BAROSSA ASSESSMENT PANEL

AGENDA

6.1 24030311 - 98 Melrose Street Mount Pleasant

PROPOSAL	Construction of building additions to existing shop (butcher) including demolition of existing verandah, construction of new verandah (over footpath) and installation of one advertising sign
APPLICANT	Jimmythebutch Pty Ltd
OWNER	Jimmythebutch Pty Ltd
APPLICATION NO	24030311
CERTIFICATE(S) OF TITLE	CT 5710/480 (Lot 656) CT 5706/828 (Lot 3)
AREA	Lot 656 – 1881 square metres Lot 3 – 1934 square metres
CURRENT USE	Shop
PLANNING AND DEVELOPMENT CODE VERSION	Version 2024.17 – 12 September 2024
PLANNING AND DESIGN CODE EXTRACT LINK	Relevant Code Extract
ZONE	Township Main Street Zone Township Neighbourhood
OVERLAYS	Character Preservation District Historic Area Hazards (Bushfire - medium risk) Hazards (Flooding - evidence required) Local Heritage Place Mount Lofty Ranges water supply catchment (area 2) Native Vegetation Prescribed Water Resources Area Traffic Generating Development Urban Transport Routes Water Resources

MT PLEASANT BUTCHER		DATE.	
PROPOSED SHOP EXTENSION		Issue Date	
98 MELROSE ST, MOUNT PLEASANT, SA 5235		DRAWING No.	REV.
FLOOR PLAN		BG_20	P4

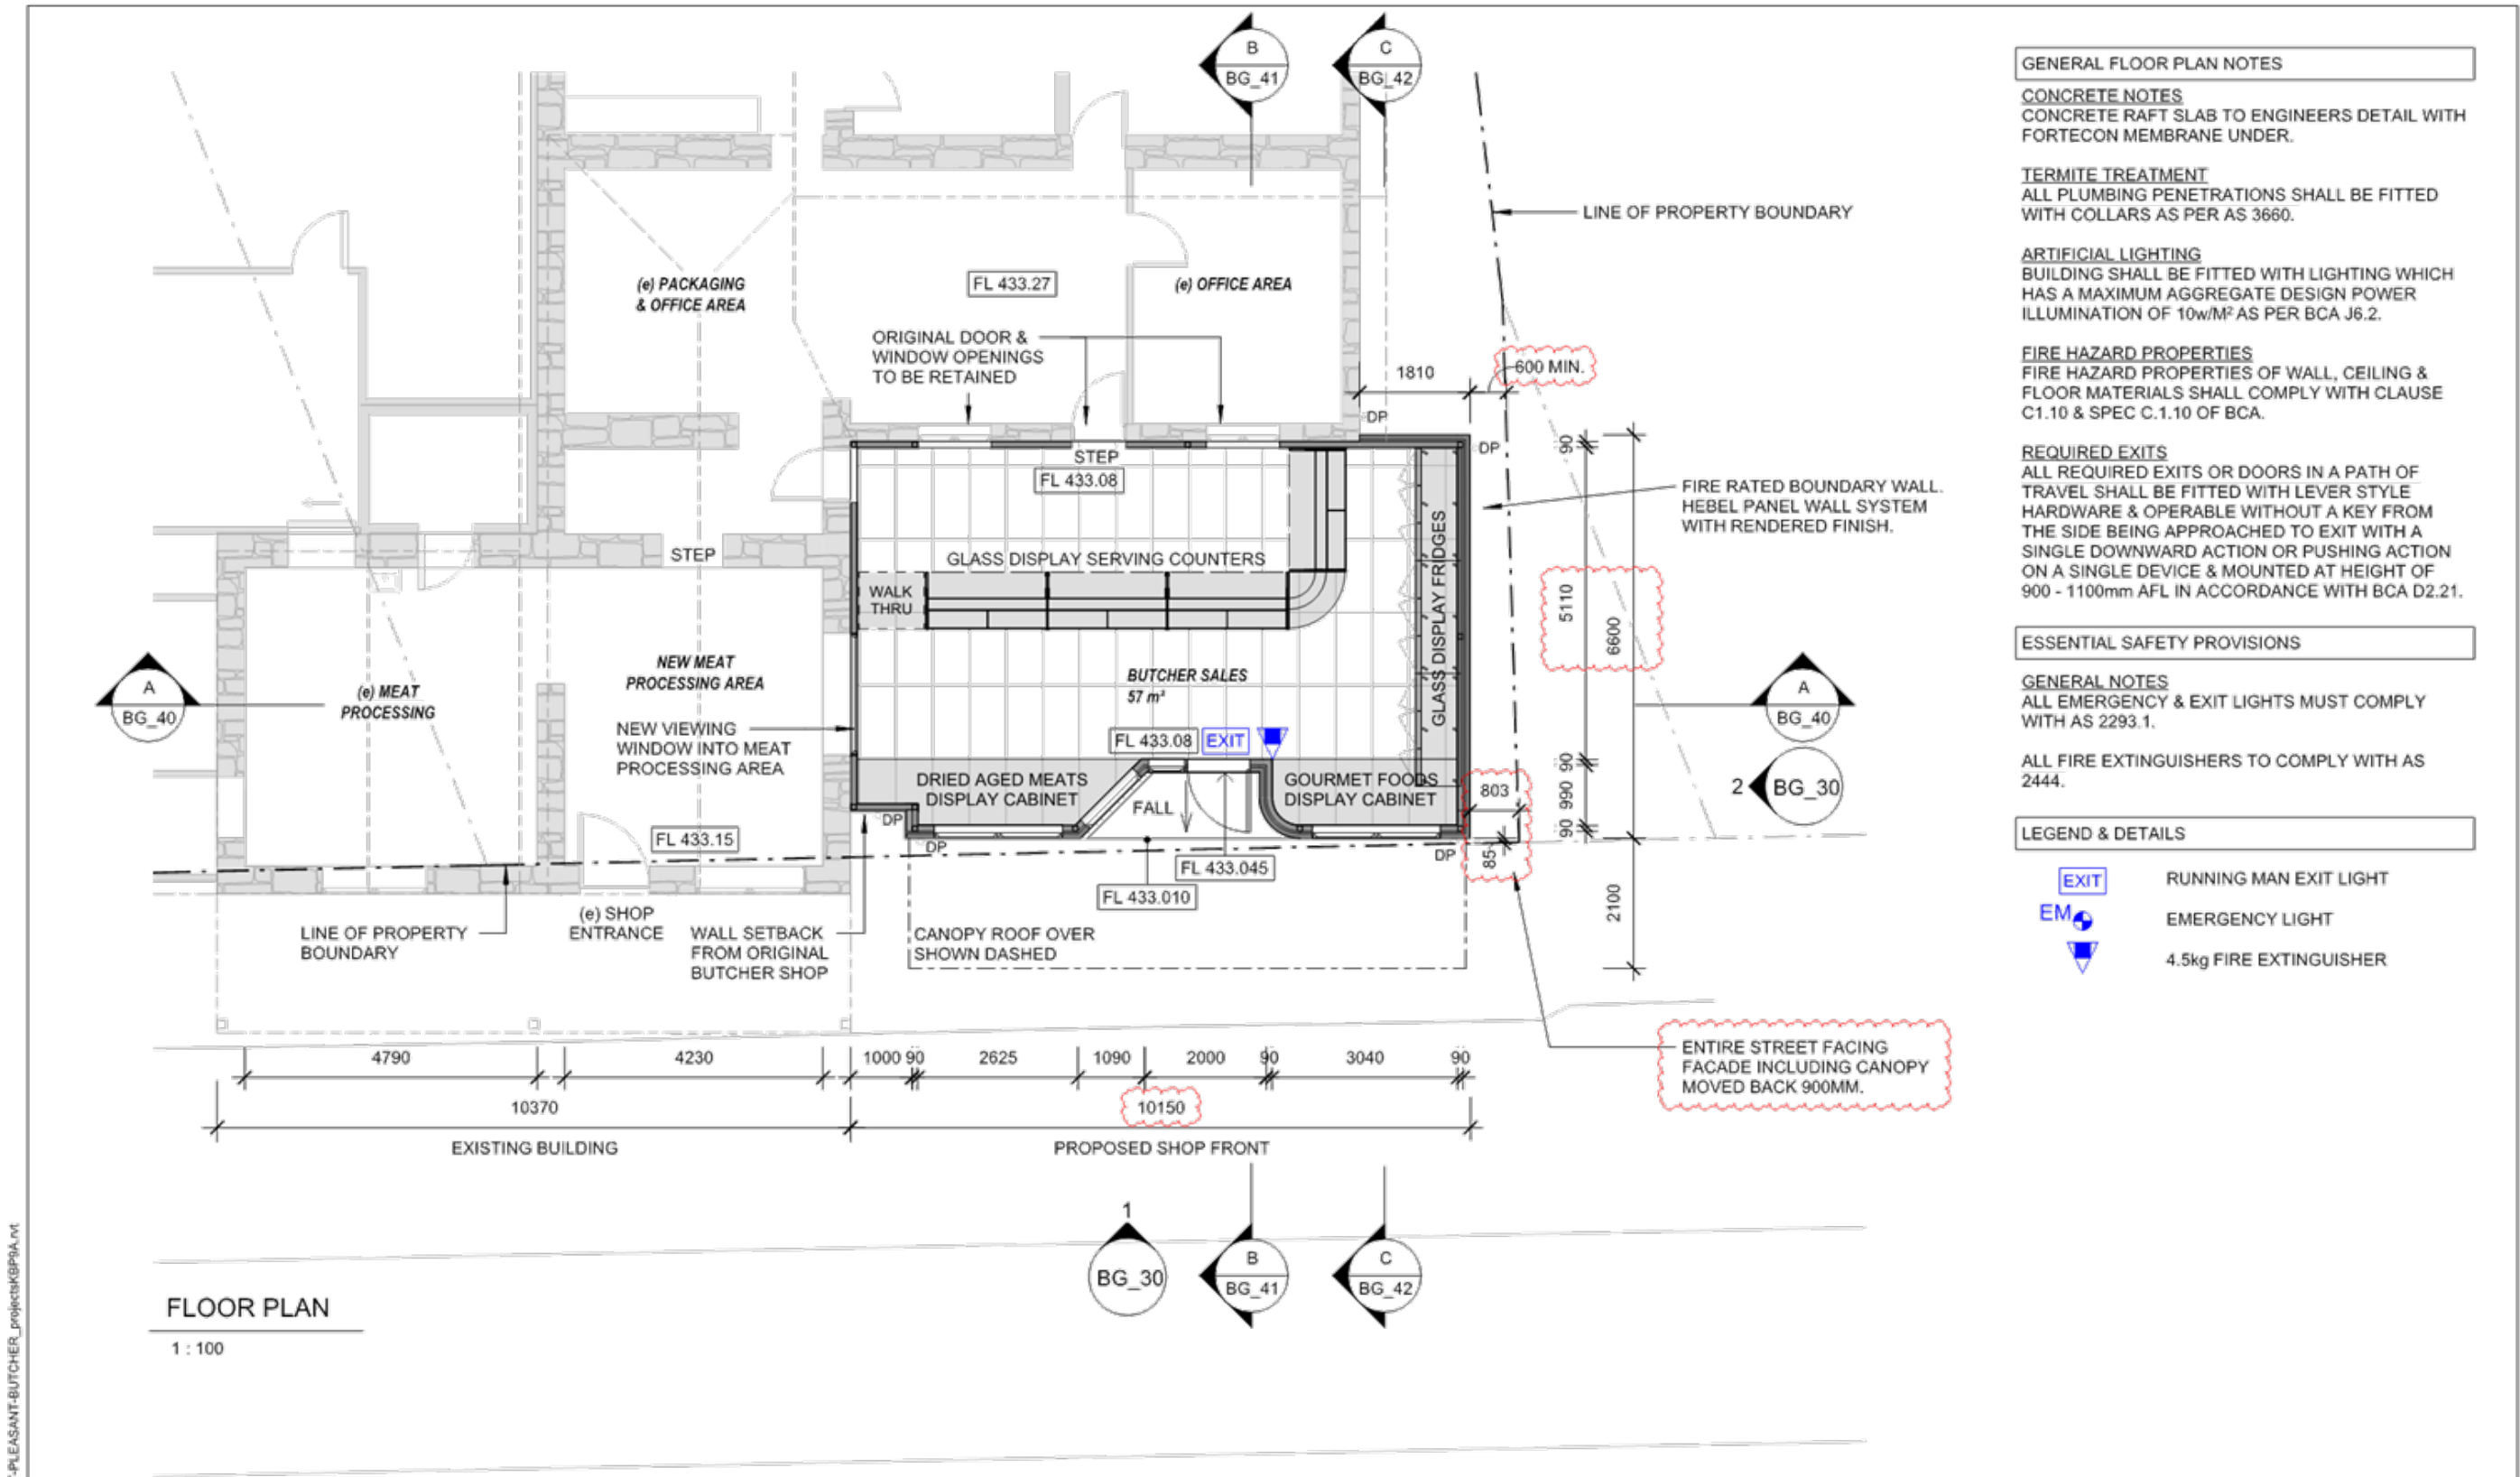
The proposed addition is sited in line with the existing building which results in the proposed building extending to within the Council road reserve footpath. Whilst Council supports ancillary verandahs and covers that provide shade and shelter for pedestrians, the proposal to encroach on this space with building walls is considered to be an impediment to the available road reserve area and is not generally supported.

MT PLEASANT BUTCHER		DATE.	
PROPOSED SHOP EXTENSION		Issue Date	
98 MELROSE ST, MOUNT PLEASANT, SA 5235		DRAWING No.	REV.
ELEVATIONS		BG_30	P4

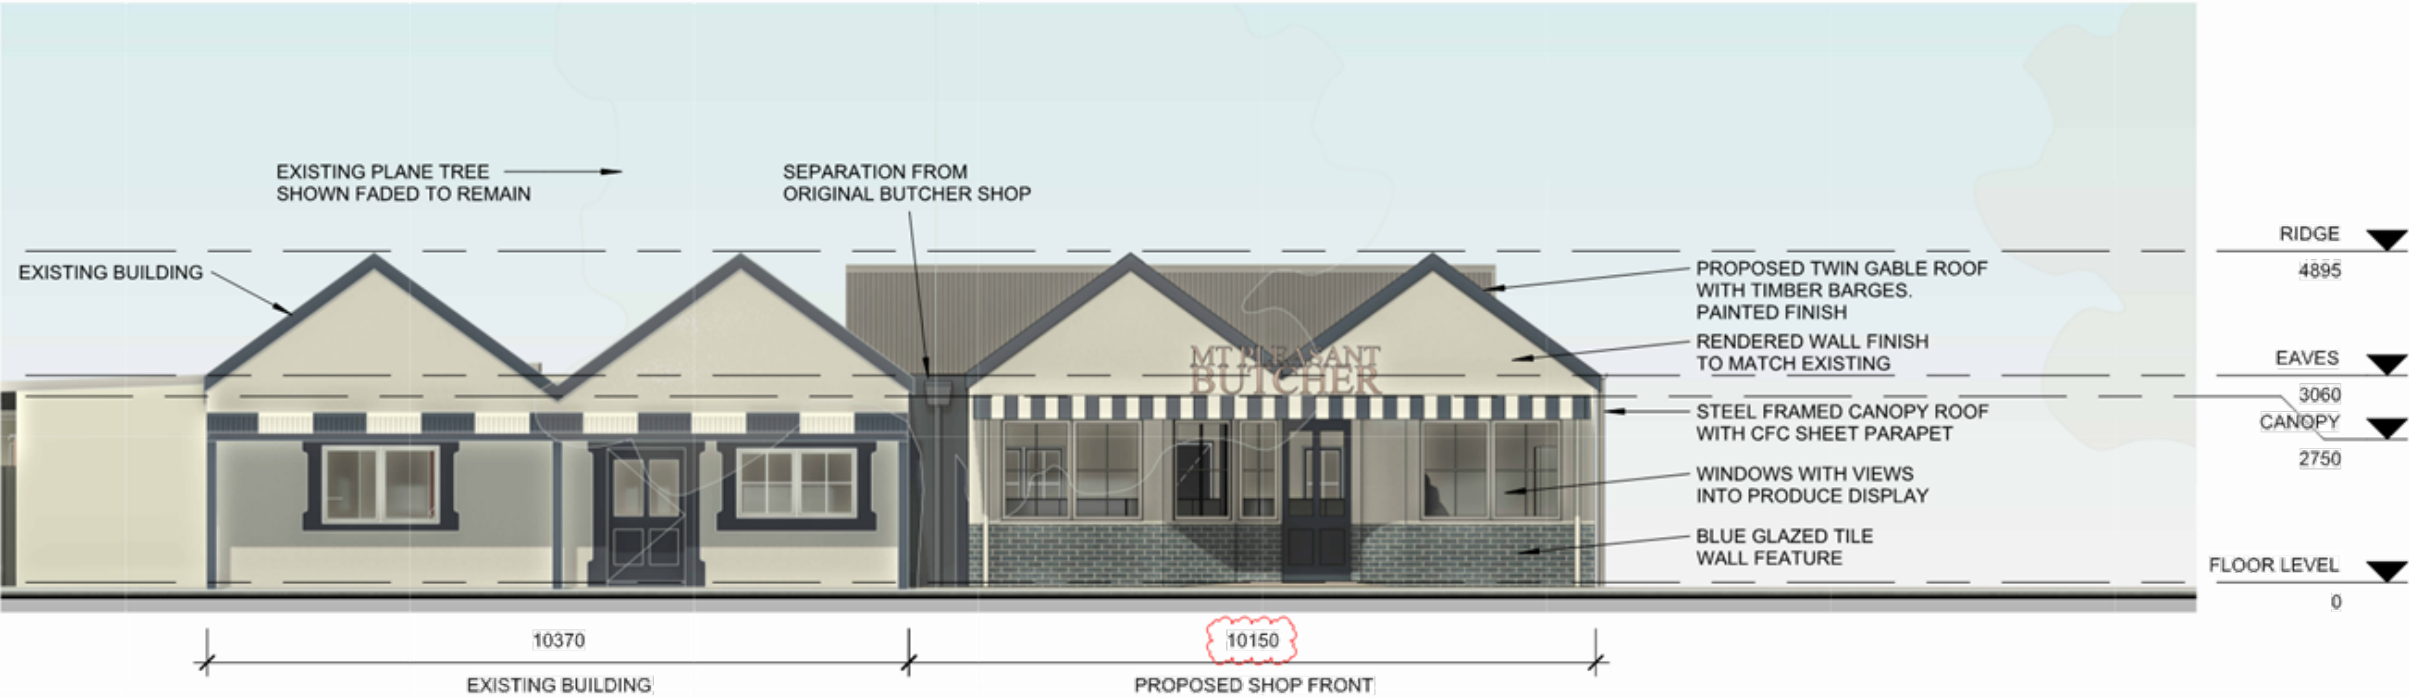
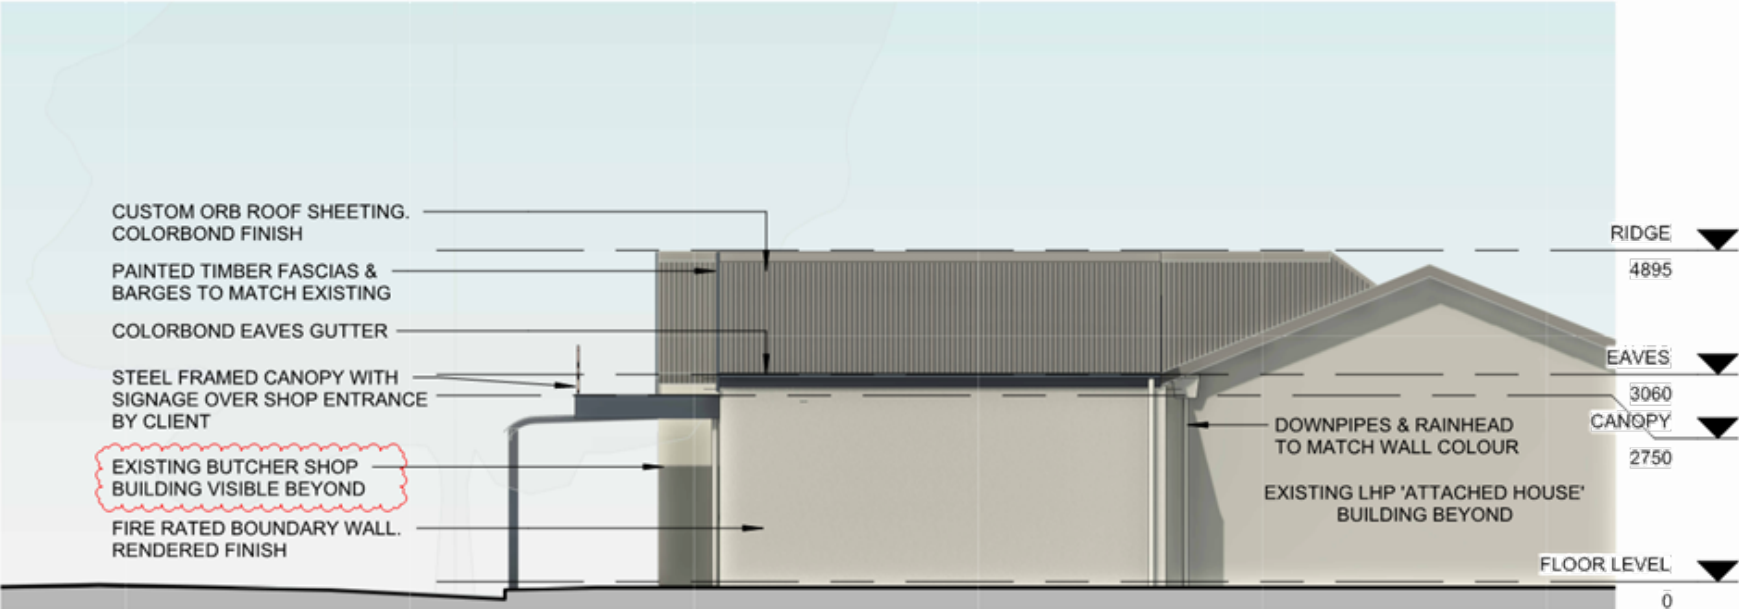
Please provide amended plans that support and maintain the heritage values of the LHP on the site which is seeking to maintain the heritage values of the 'Butcher's Shop & Attached House'.

- A **recessed connection** between the existing shopfront and the new addition, using a flat roof break and wall setback to clearly distinguish the new from the old;
- **Retention of the original door and window openings** on the attached house, which will remain visible from within the new shop interior;
- **High-level windows** with views out to the existing LHP attached house roof beyond.
- A **revised verandah design** with a contemporary profile to avoid replication and maintain a respectful contrast between old and new elements.

SECTION A
1 : 50

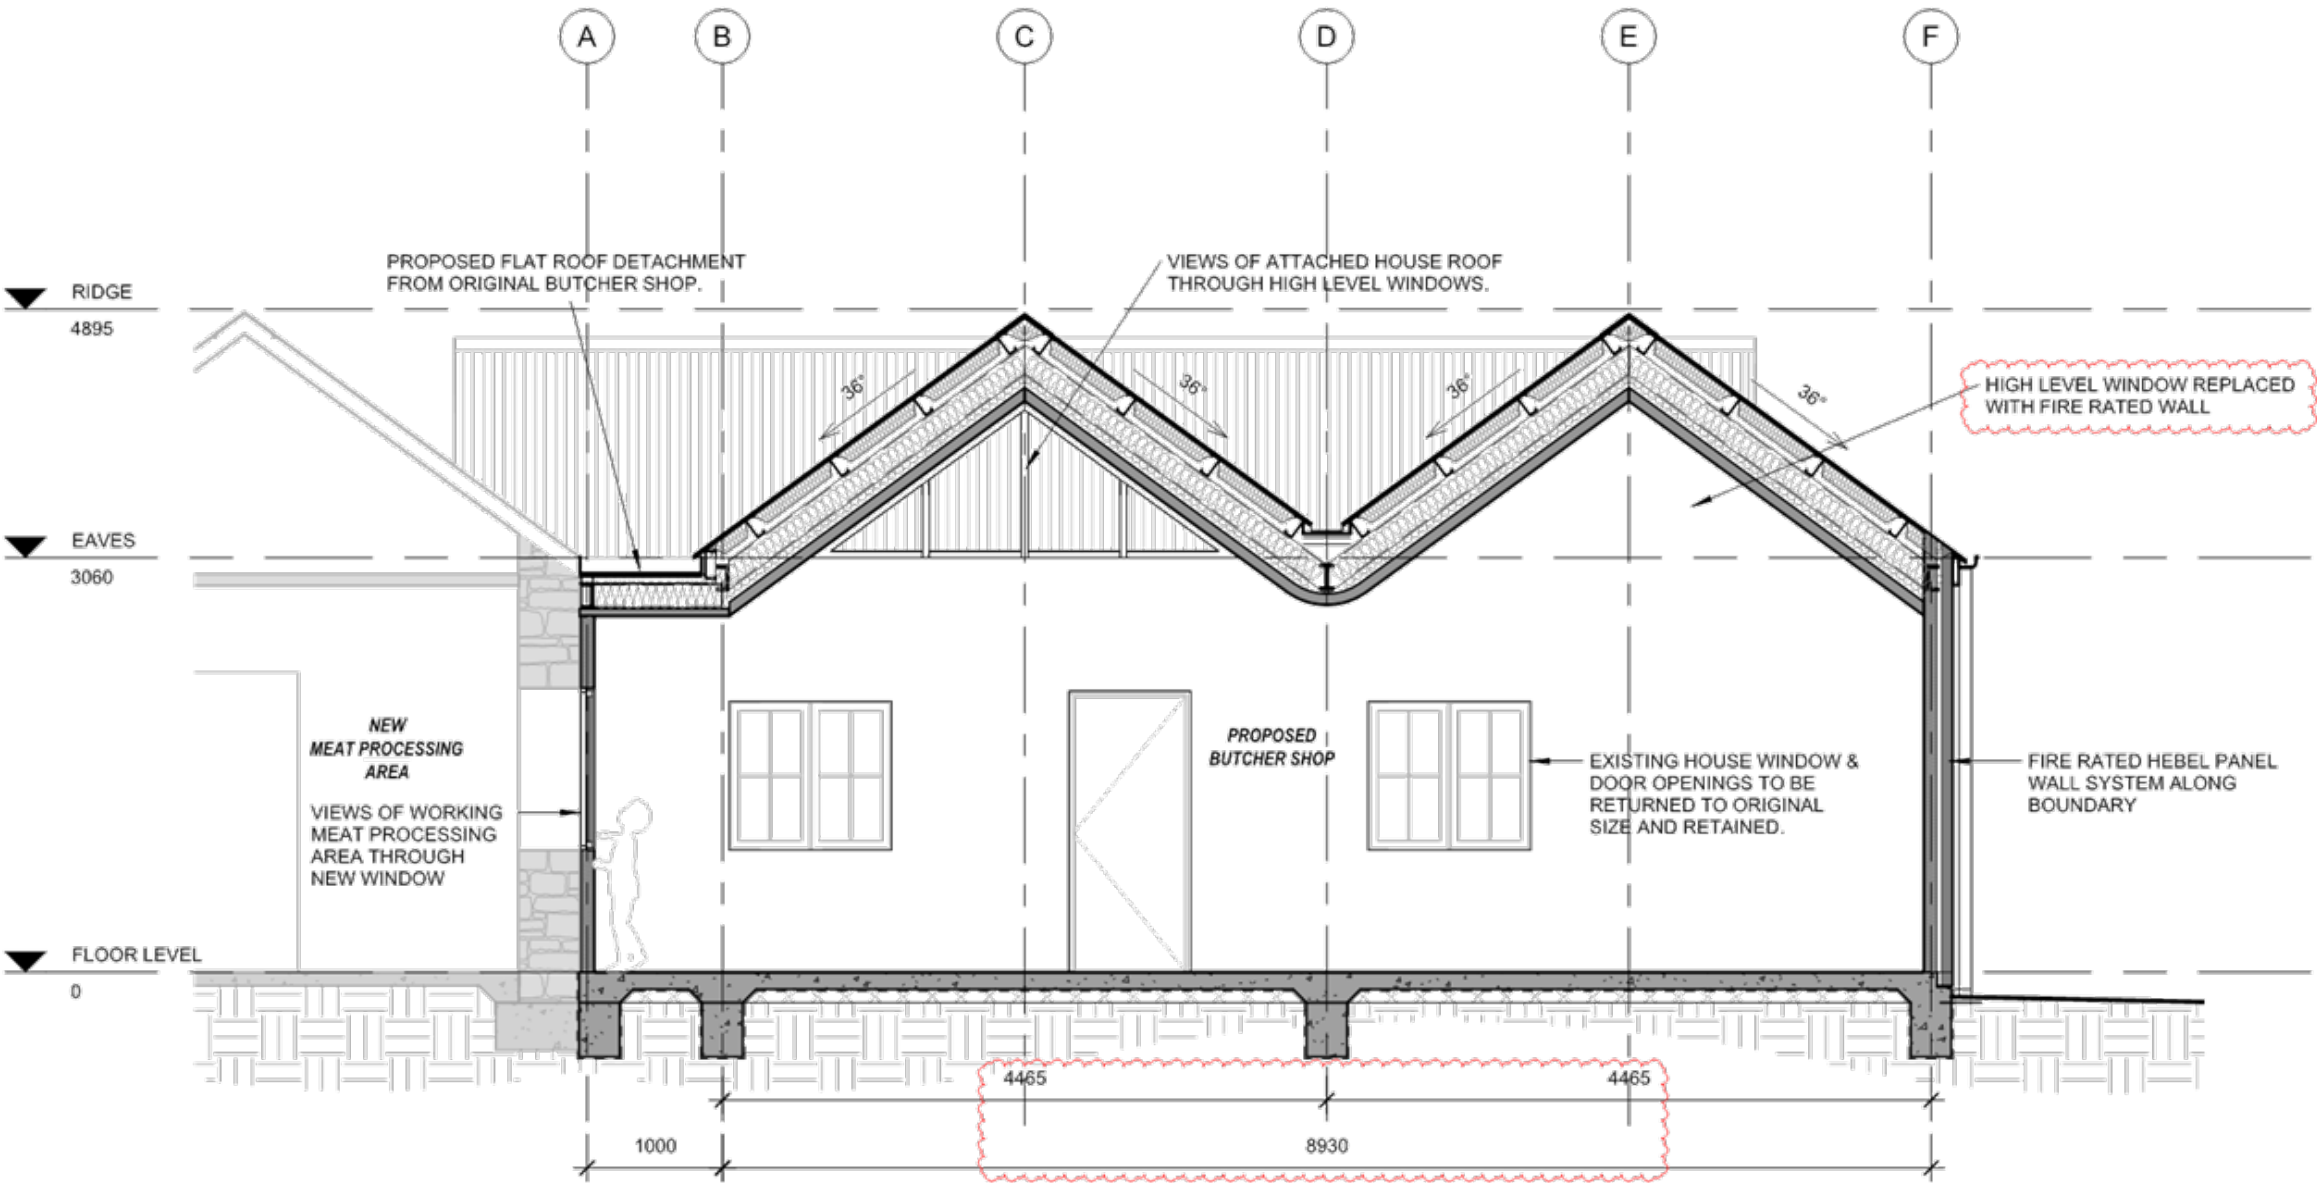
At the same time, I've had to remove a high-level window in the gable end that will be a fire wall return. See BG_40 section.
